Director - Infrastructure Projects,
Department of Planning and Environment
Number: SSI 13_6136
Major Projects Assessment
GPO Box 39
SYDNEY NSW 2001

NorthConnex Application Number: SSI 13_6136

Please find below my **submission** in response to the exhibition of the EIS for the proposed NorthConnex tunnel project.

Figure 7: Option Preferences from Community Consultation.

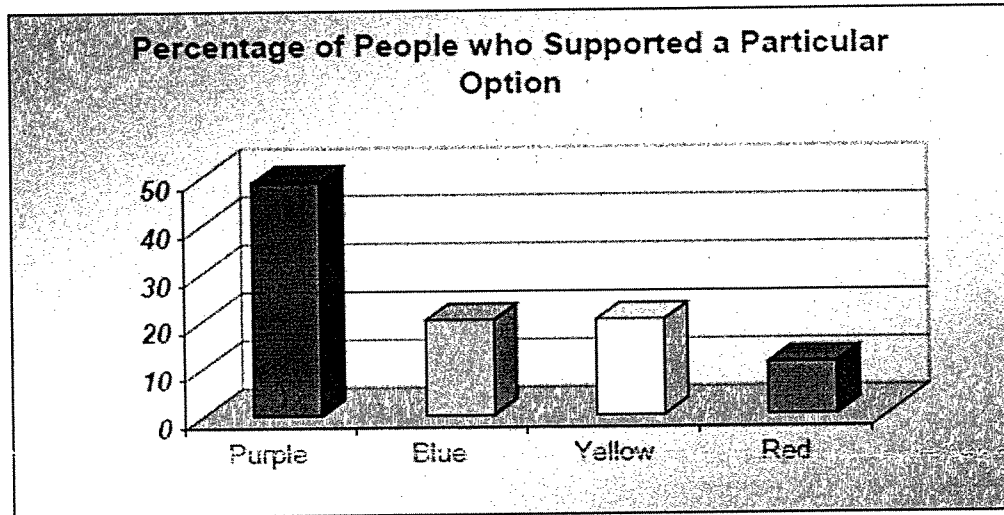
- 2.1. Crucially, the preferred (Purple) option was overwhelming supported by stakeholders in the consultation process (see Figure 7 below). From our

attendance at public meetings and discussions with residents, this remains the preferred option, with an extension of the tunnel to the north.
